Fire Station 10 Community Meeting #2

March 16, 2017
6:00 pm

Design Update

COMMENTS FROM PREVIOUS COMMUNITY MEETING

1

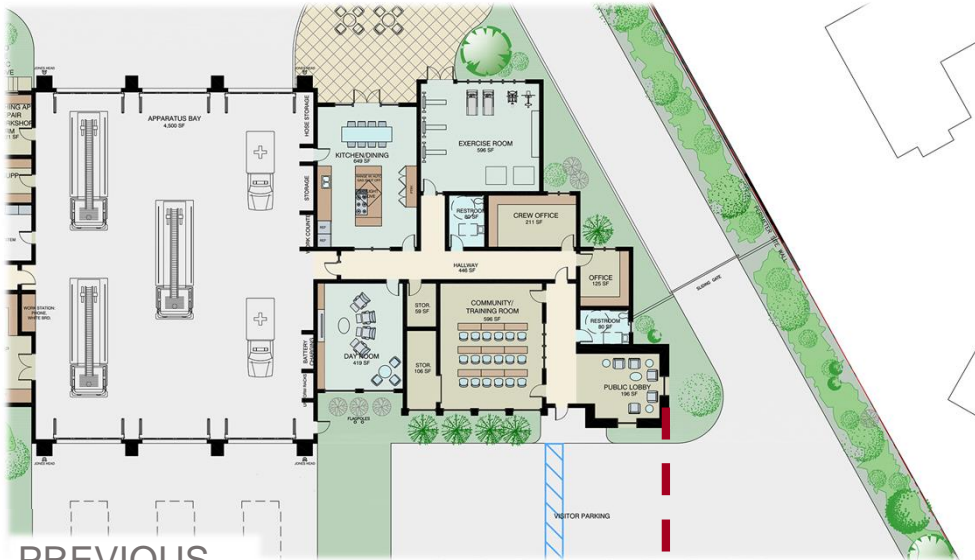
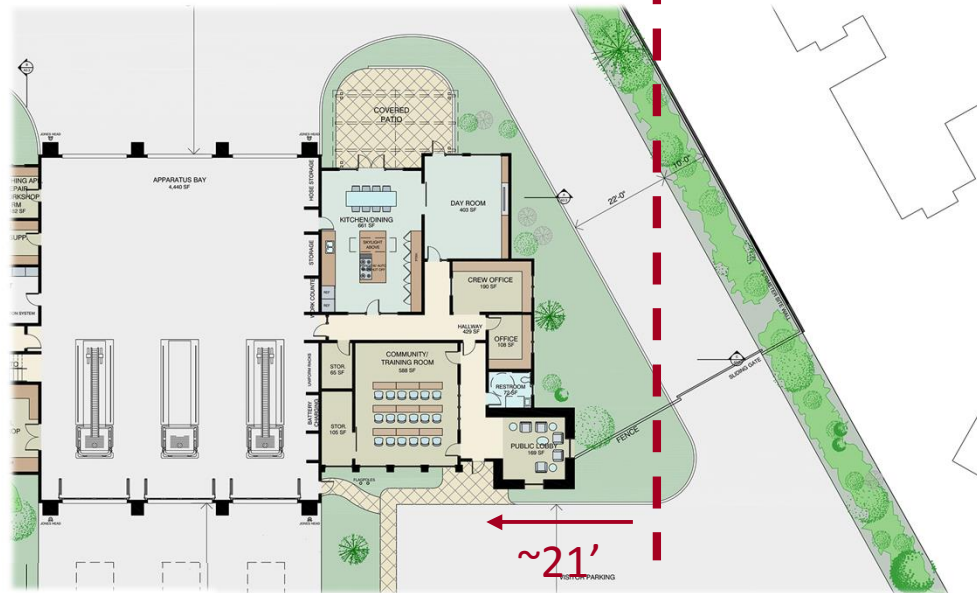
1. Request for tower and other building elements be moved to the west.
2. Preferred balanced appearance of having more of the building on west side.
3. Parking spaces.
4. 2nd driveway.
5. Fuel tank location.
6. Trash enclosure location and view.
7. Existing trees.
8. Planting along shared boundary.
9. Style of gate fence.
10. Green buffer at sidewalk.
11. Lighting and audio.
12. Communication tower.

TOWER HAS MOVED FURTHER WEST BY APPROXIMATELY 21 FEET.

EXERCISE ROOM HAS MOVED TO THE WEST SIDE OF THE BUILDING.

EAST SIDE OF BUILDING IS SMALLER.

3 & 4

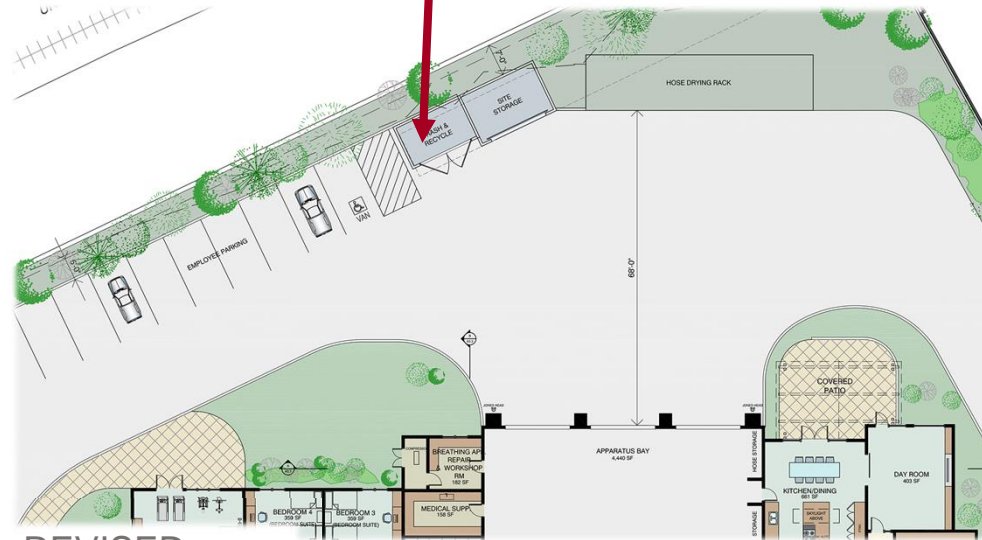
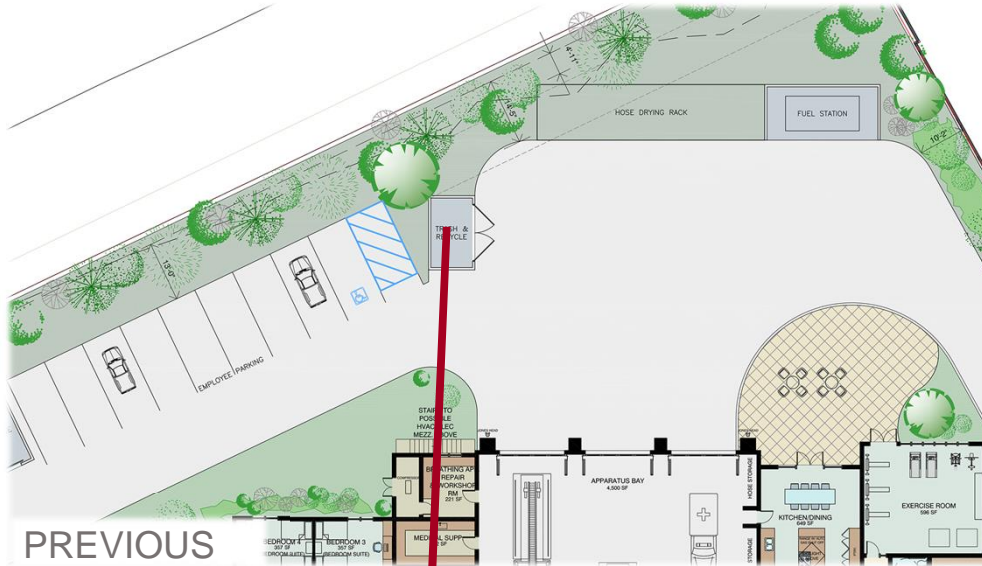
3. PARKING SPACES

4. 2ND DRIVEWAY

11 & 12

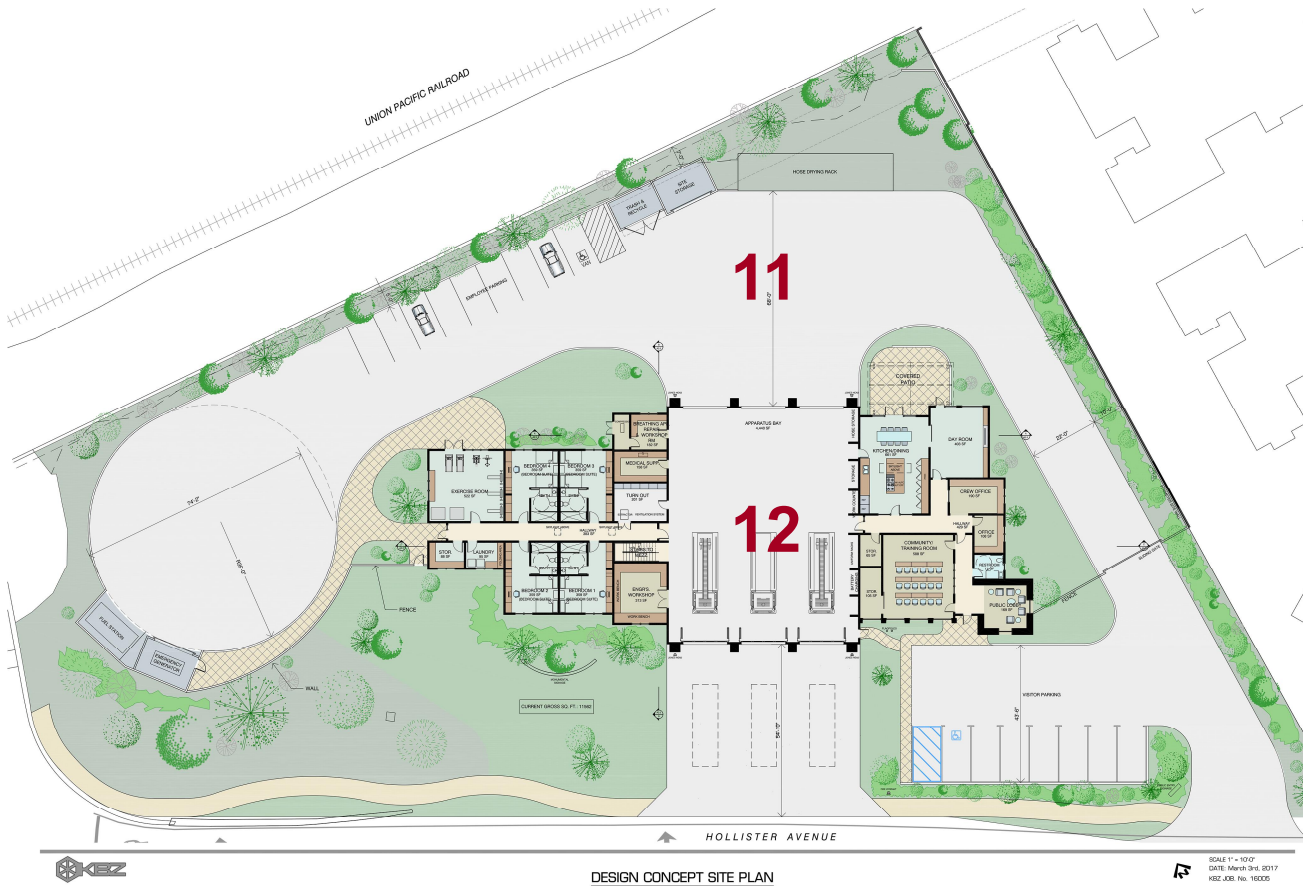
- 11. LIGHTING AND AUDIO
- 12. COMMUNICATION TOWER
